MEMORANDUM

County Plan No.: SP-100-00 (Amend SP-076-01)
Project Name: MIDLANDS ROAD LOT 2
Stormwater Management Facility: BMP #2 Dry Pond (3917 MIDLANDS RD)
Phase: I II III

Lot 2, Midlands Road
Record Drawing Plan
County Plan Number SP-100-00
BMP ID No. MC 047

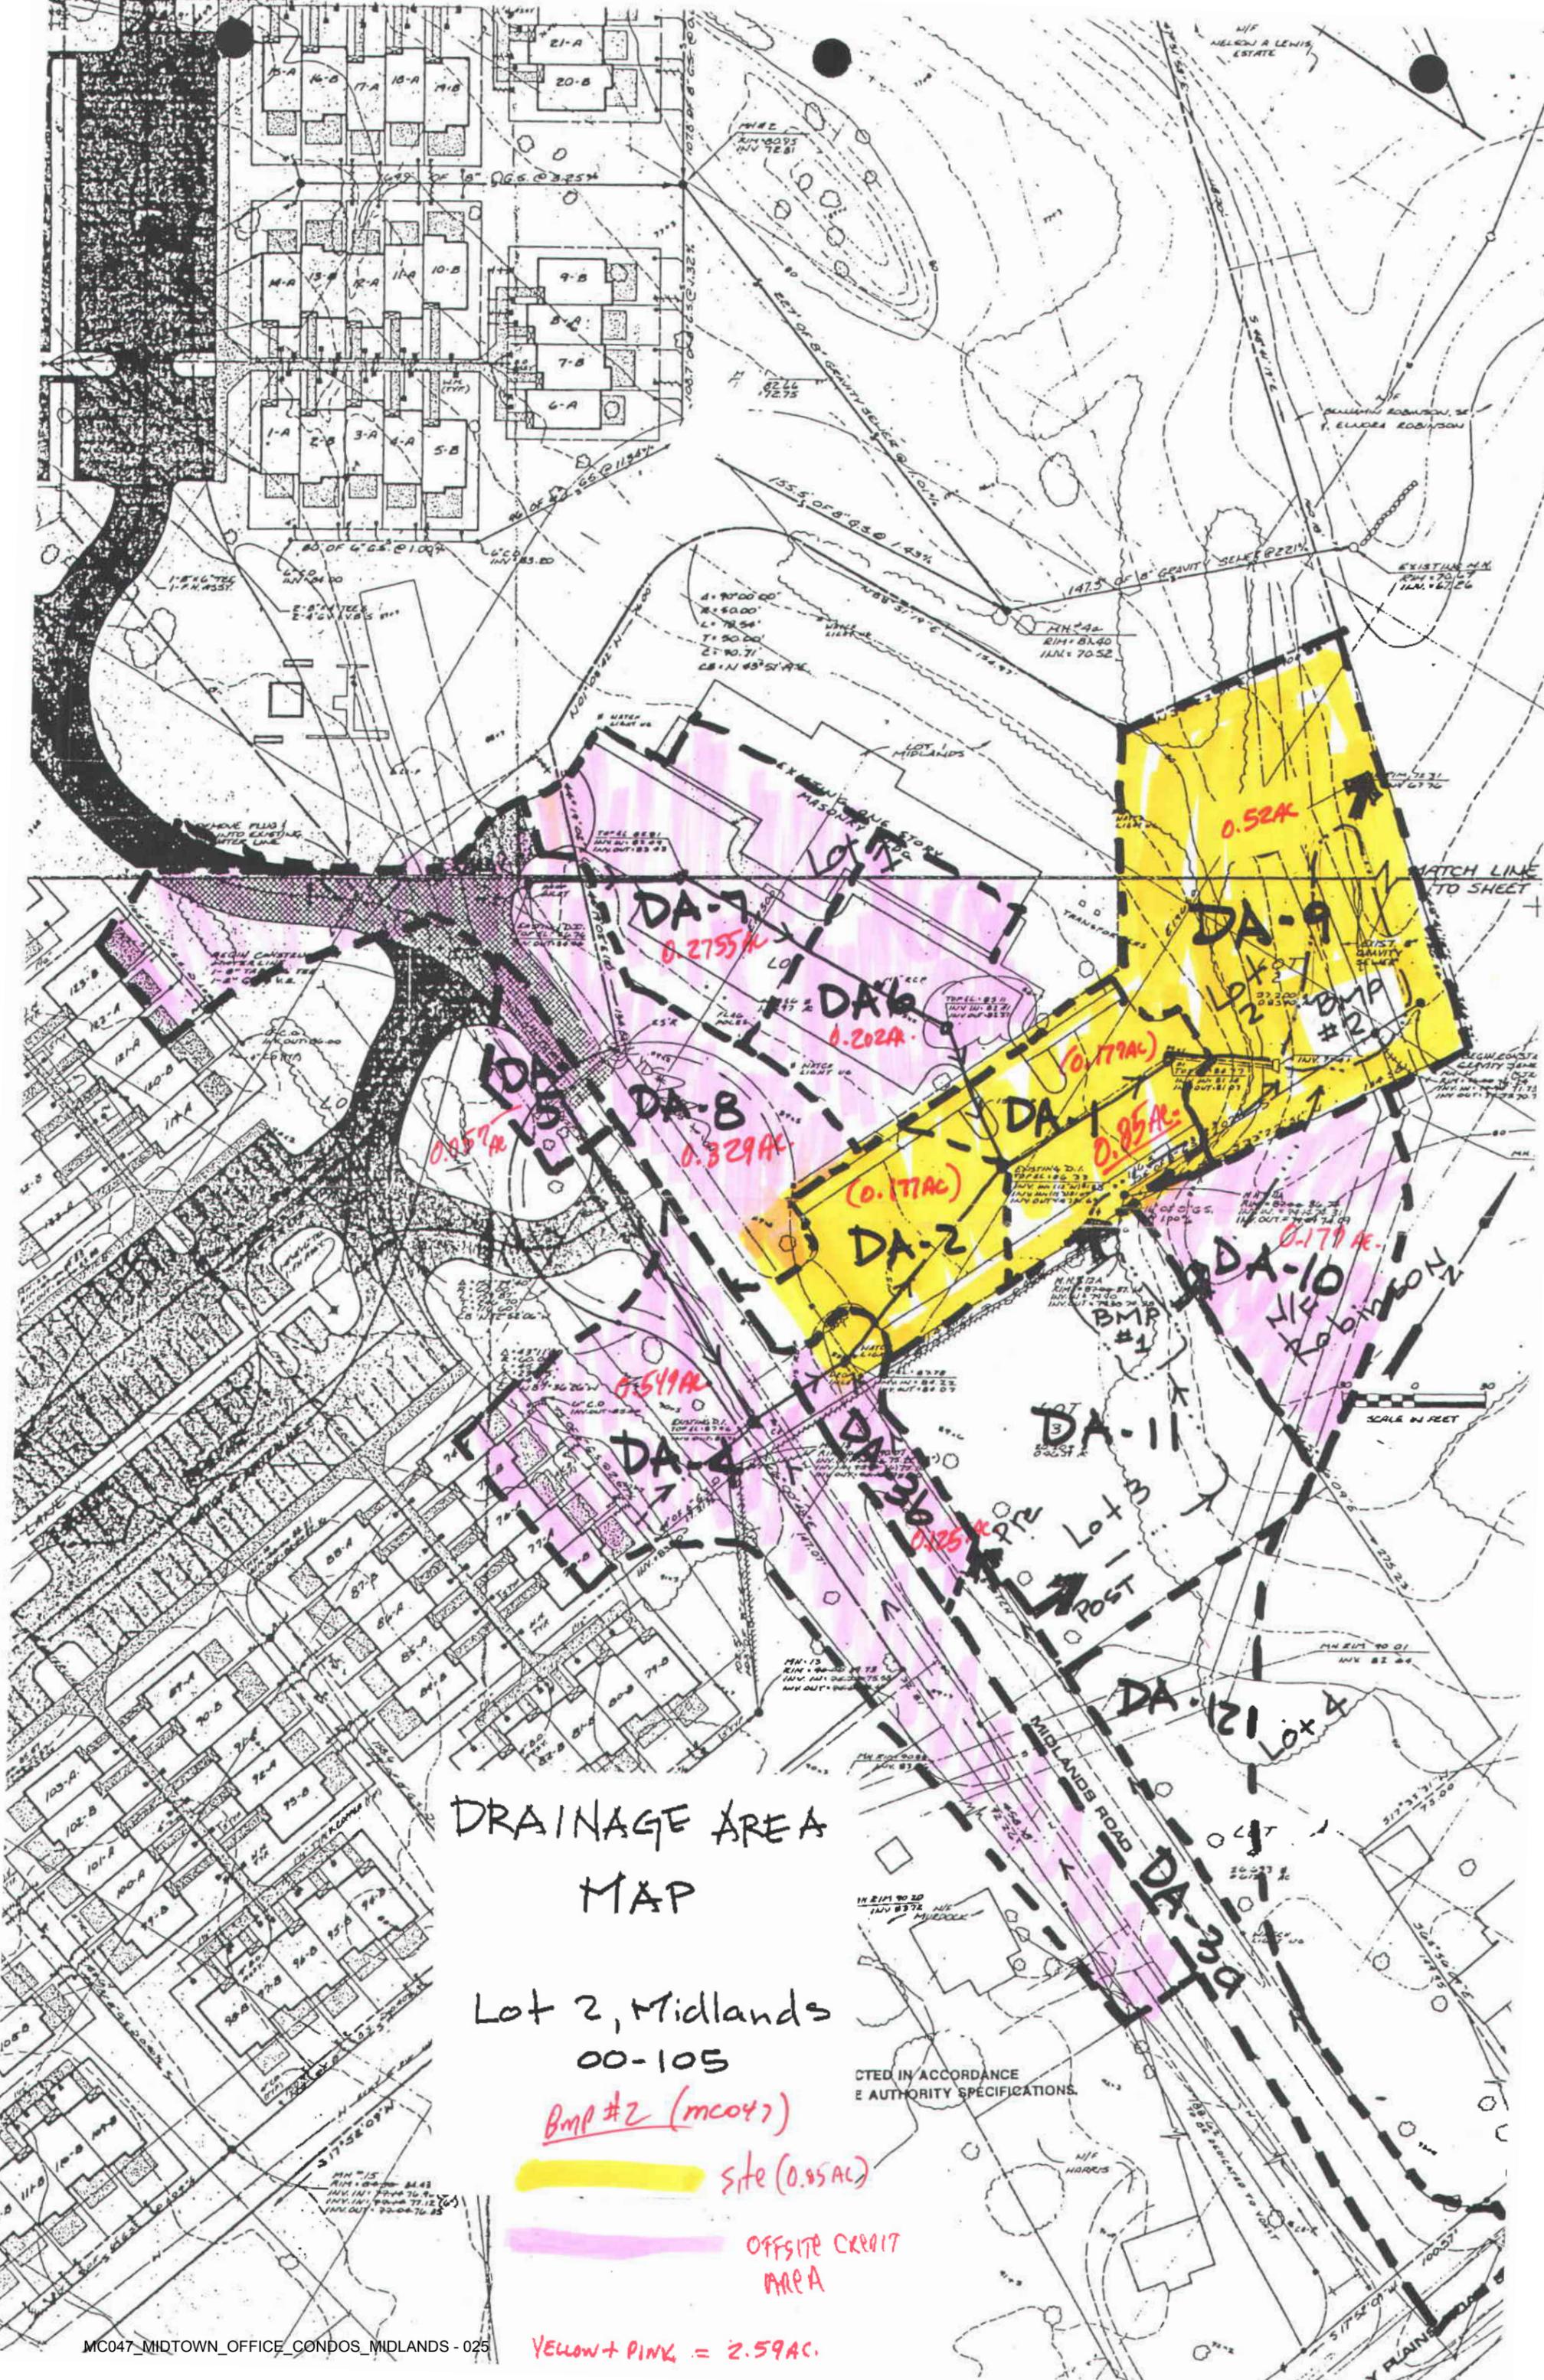
✓ 3. Record drawing RD1 reflects use of a 15-inch HDPE barrel through the dam embankment. Based on field inspection, an 18-inch aluminized pipe barrel with an end section was installed. Correct the discrepancy on the record drawing.
5-23-02

✓ 4. Add the stormwater maintenance easement note from Sheet C2 and the maintenance plan from Sheet C5 of the approved plan to record drawing RD1. As the record drawing will be utilized for future inspection and maintenance purposes, these items should be on the record plan.
5-23-02

6. Sign and date the professional seal on record drawing sheet RD1.

7. If possible add the following County identifiers to the lower right hand corner of record drawing RD1: County Plan Number SP-100-00 and BMP ID No. MC 047.

Record drawing RD1 reflects use of a 15-inch HDPE barrel through the dam embankment. Based on field inspection, an 18-inch aluminized pipe barrel with an end section was installed. Correct the discrepancy on the record drawing. **Complete**

Add the stormwater maintenance easement note from Sheet C2 and the maintenance plan from Sheet C5 of the approved plan to record drawing RD1. As the record drawing will be utilized for future inspection and maintenance purposes, these items should be on the record plan. **Complete**

Sign and date the professional seal on record drawing sheet RD1. ✓

If possible add the following County identifiers to the lower right hand corner of record drawing RD1: County Plan Number SP-100-00 and BMP ID No. MC 047. **Complete**
